**Subject:** Upper South Creek Advanced Water Recycling Centre (SSI-8609189) Response to Submissions Report

### Attachment A – EHG comments on Upper South Creek Advanced Water Recycling Centre RtS Report

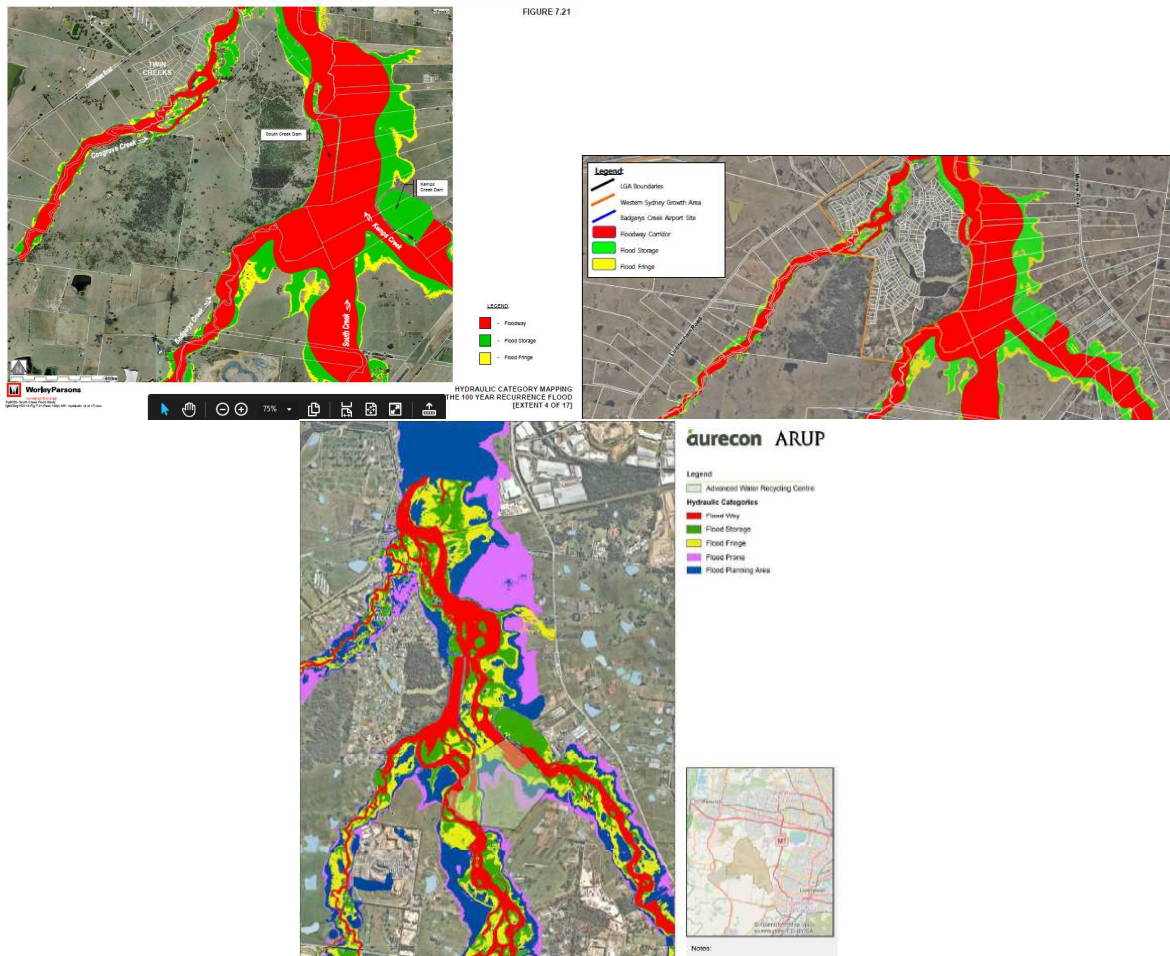
EHG has previously addressed the inconsistency between the Aurecon ARUP flood assessment 2021 results and Penrith's WorleyParsons (2015) results. In addition, the figures below highlight the inconsistency between Aurecon ARUP flood assessment 2021 results and INSW 2020 results.

The figures above show significant inconsistency in flood behaviour results by Aurecon ARUP flood assessment 2021 (bottom figure) comparing to Council’s 2015 results (upper left figure) and INSW flood assessment (upper right figure).
